Document Change Notice (DCN)

DCN No.: 9704763

DOC No. RC5037

SUBJECT EVALUATION OF MFW PIPING SYSTEM DUE TO SGR (UNIT 1 LOOP D)

FIGURE 11-49. LOOP D REACTION FORCE DIAGRAM

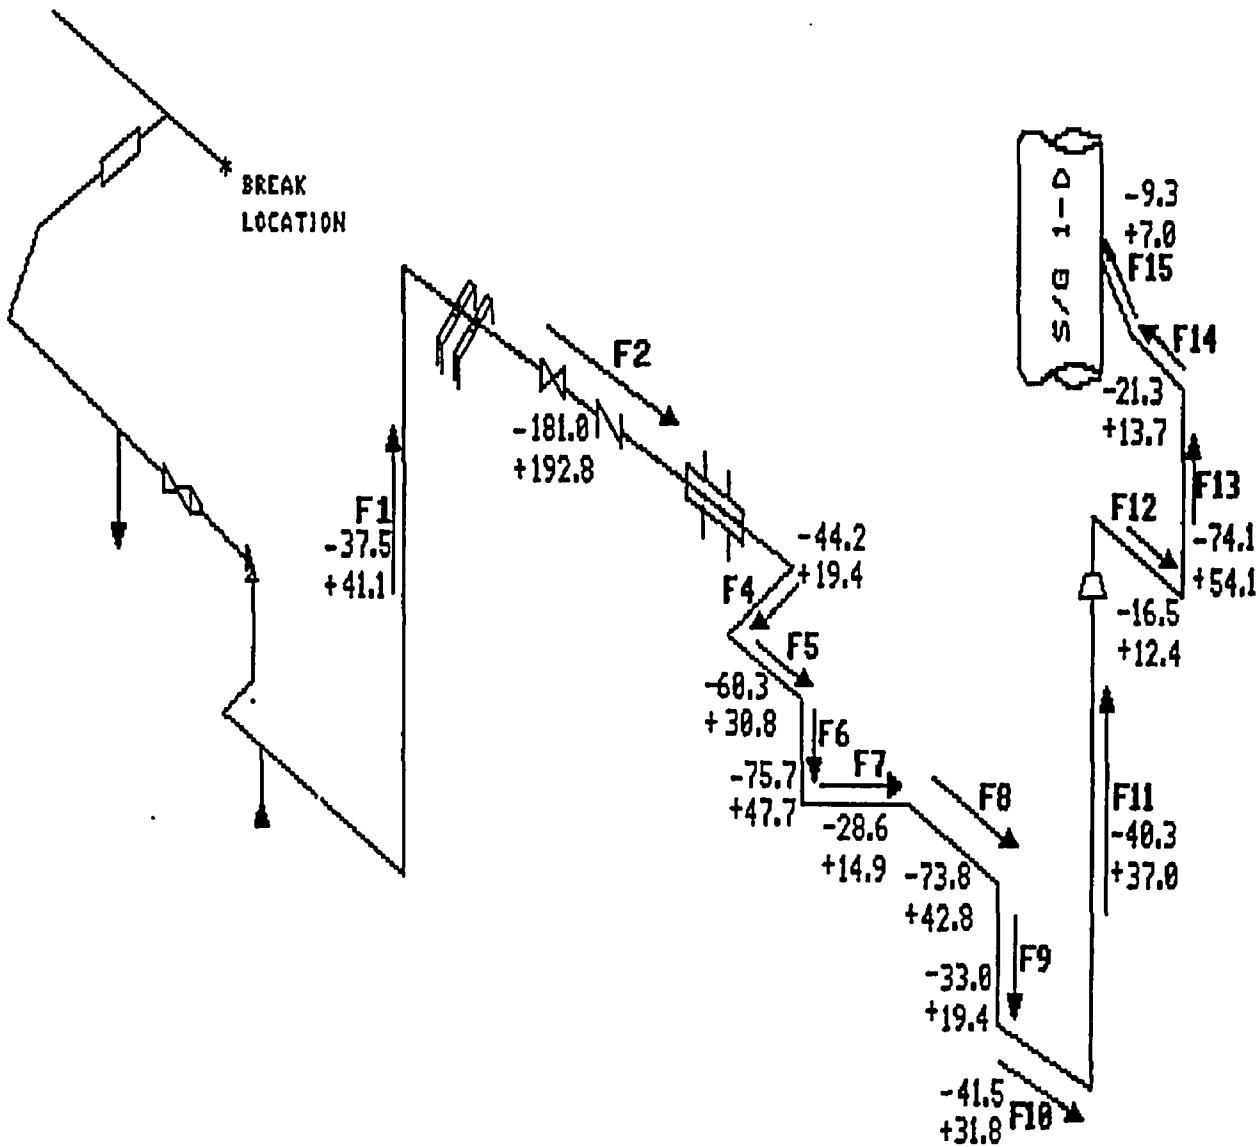
- CHANGE IN MOVEMENTS DUE TO REVISED WATER HAMMER TRANSIENT ANALYSIS FROM 75% TO 100% IS NEGLIGIBLE AND DOES NOT IMPACT THE EXISTING PIPE SUPPORT DESIGN.
- MAXIMUM LOAD FOR WHICH THE PIPE SUPPORT IS QUALIFIED IS LISTED. IT IS EITHER THE LOAD FOR WHICH THE SUPPORT WAS QUALIFIED PRIOR TO SGR OR THE 75% ANALYSIS LOAD WHICH WAS USED TO REVISE THE CALCULATION.
- SUPPORTS NOT LISTED ABOVE HAVE BEEN REVISED TO INCORPORATE THE 100% ANALYSIS LOADS.
